Dear reviewer,

Answer to the general comment:

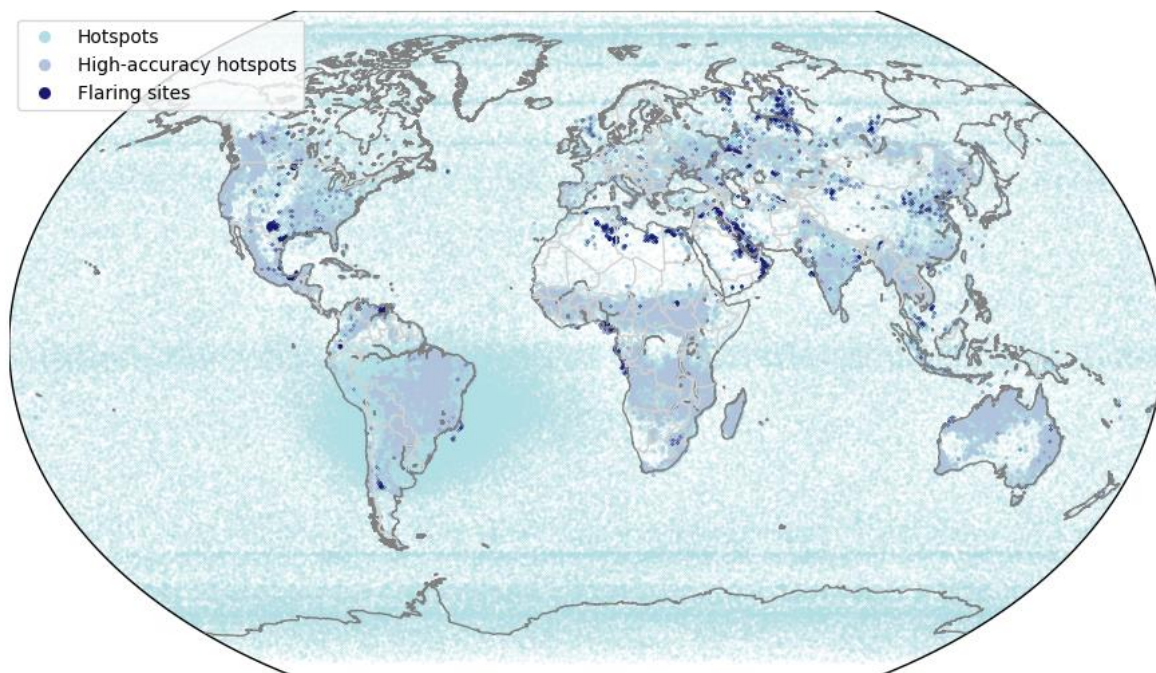
I have concerns about this section. Your paper focuses on gas flaring, the previous one (Caseiro et al., 2018) on hotspots. For this reason, you can join Figures 4, 5, 6 using three colors for discriminating hotspots, high confidence hotspots and flaring sites. Besides, I do not understand why you compare the SLSTR global detections for 2017 with the VNF in 2012. The VNF data for 2017 are available; you indeed use them in section 3.3.

Figures 4, 5 and 6 were merged into a single figure. Please see the resulting figure below.

Figure 7. Average flaring temperature (K) at the 6232 flaring locations.

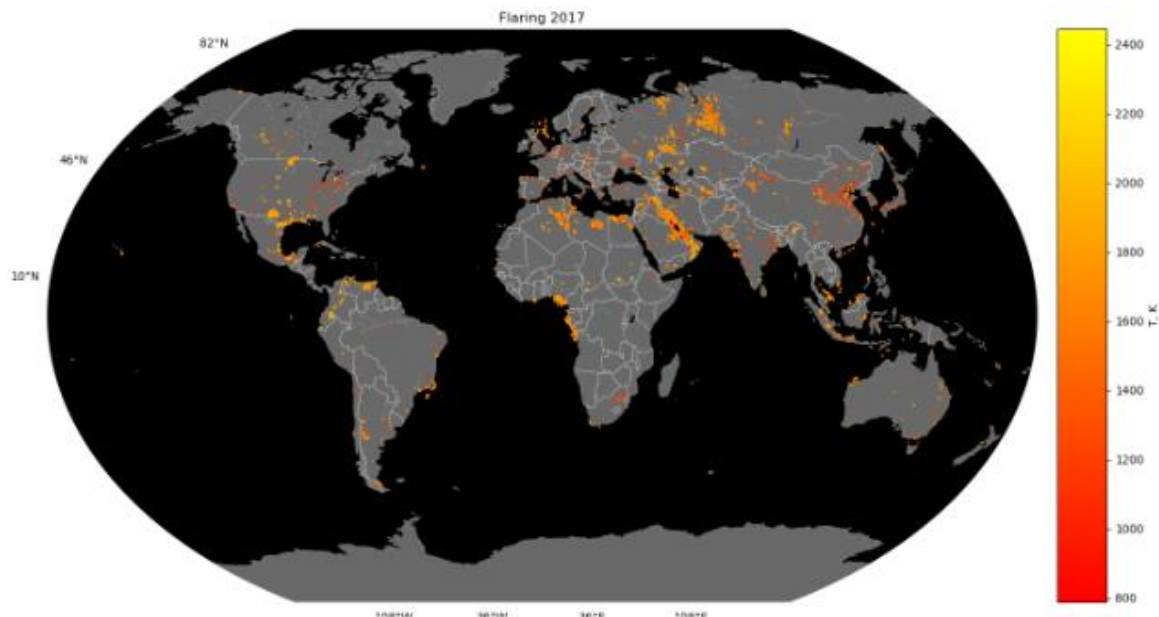
- Figures 10, 11 and 12 are not useful, in my opinion they could be removed. You can indeed add before Figure 9 and Figure 13, respectively, a global map (in color scale) showing the temperatures and RP values for the 6232 sites.

We have removed Figures 10, 11 and 12.

We have added figures for the global average T distribution:
